IEC Publication 60360
(Third edition – 1998)

**STANDARD METHOD OF MEASUREMENT
OF LAMP CAP TEMPERATURE RISE**

CORRIGENDUM 1

Figures 1 and 2

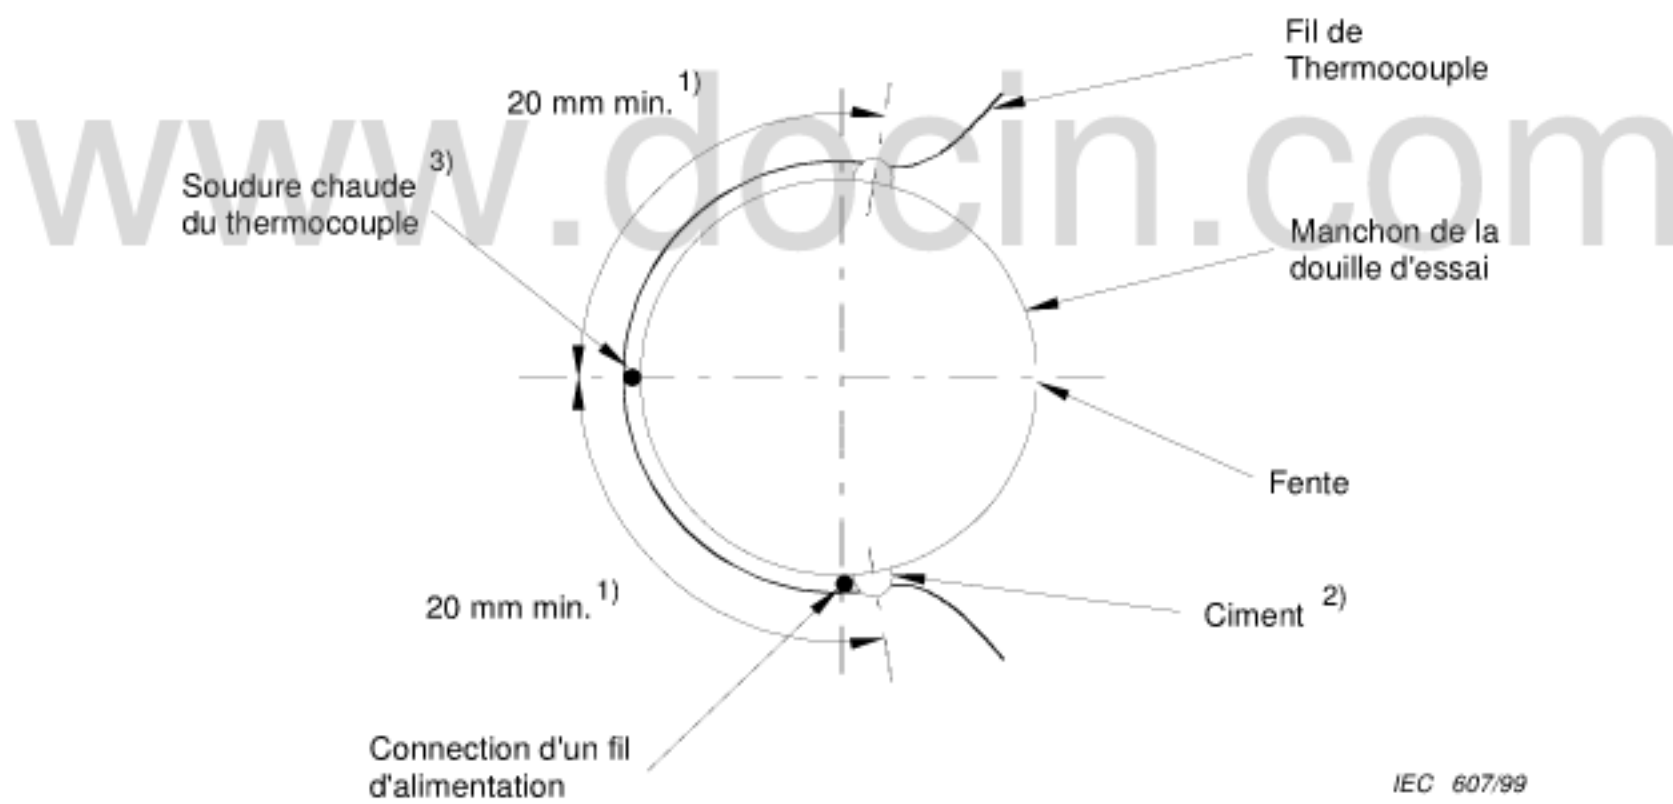
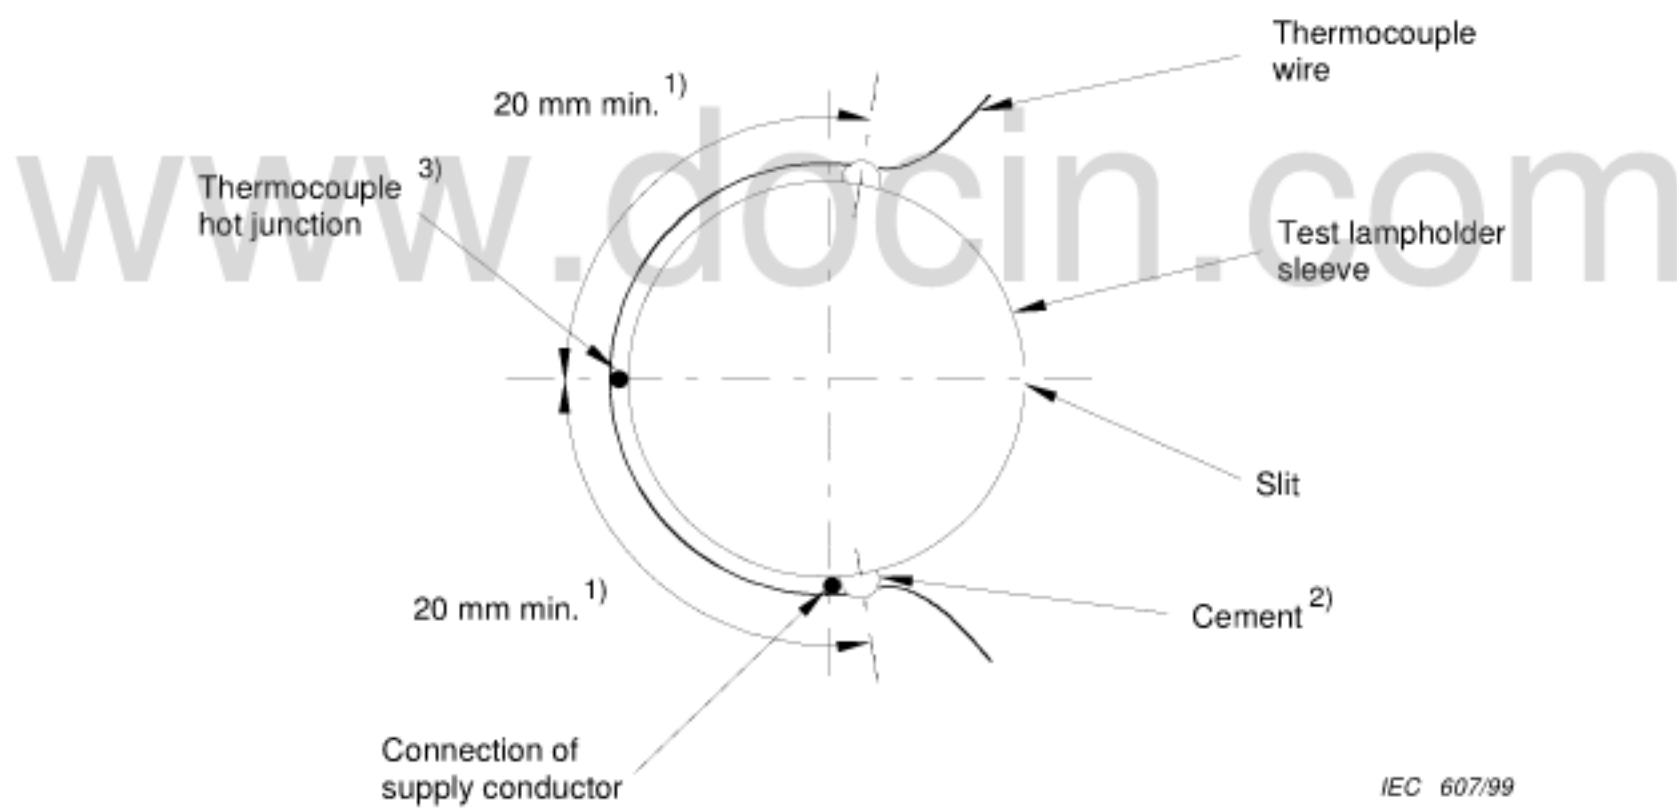
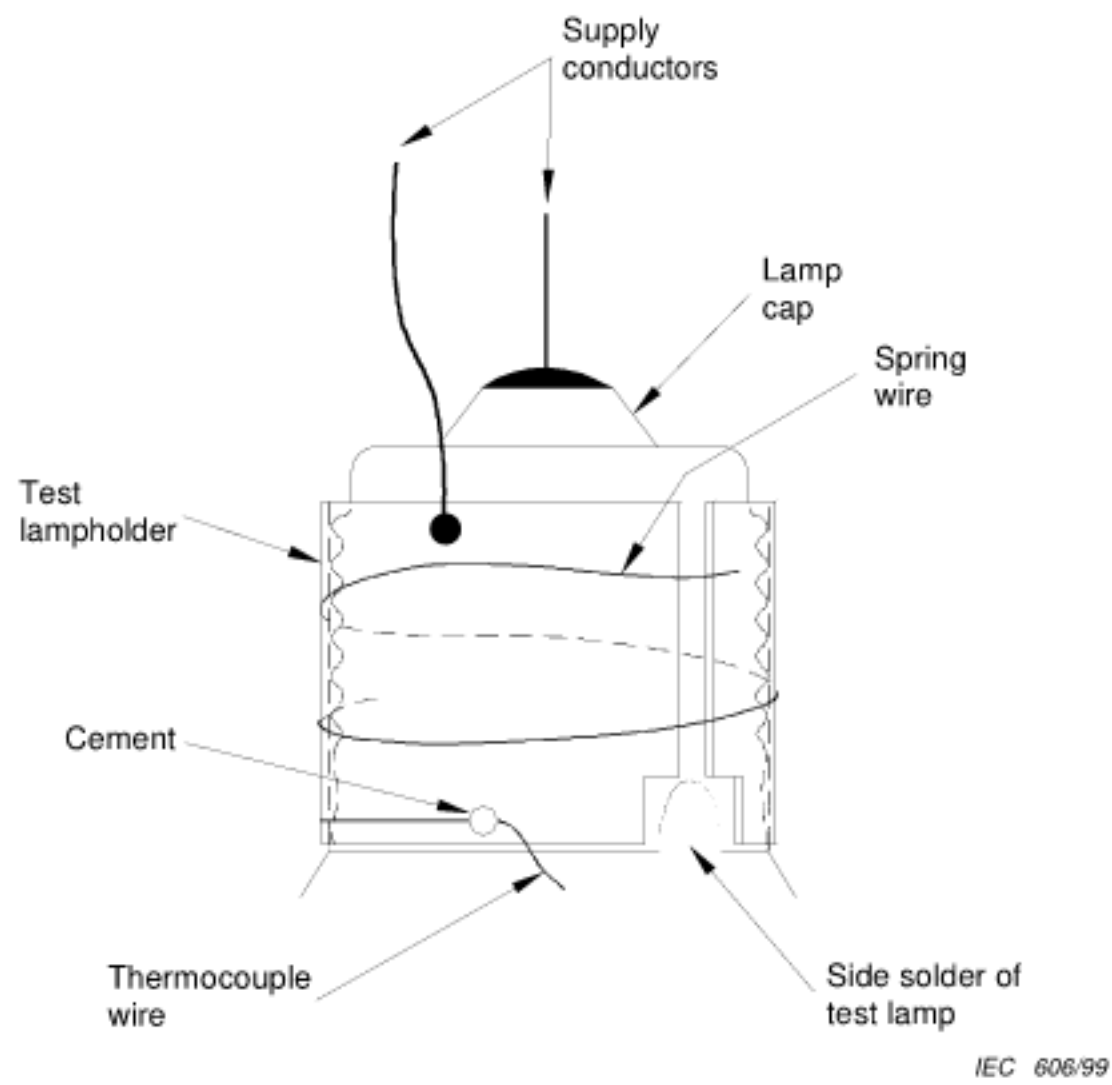
Replace the respective existing diagrams by the following amended diagrams.

- 1) See note 1 to 7.3.
- 2) See note 2 to 7.3.
- 3) Attached as specified in 7.3.
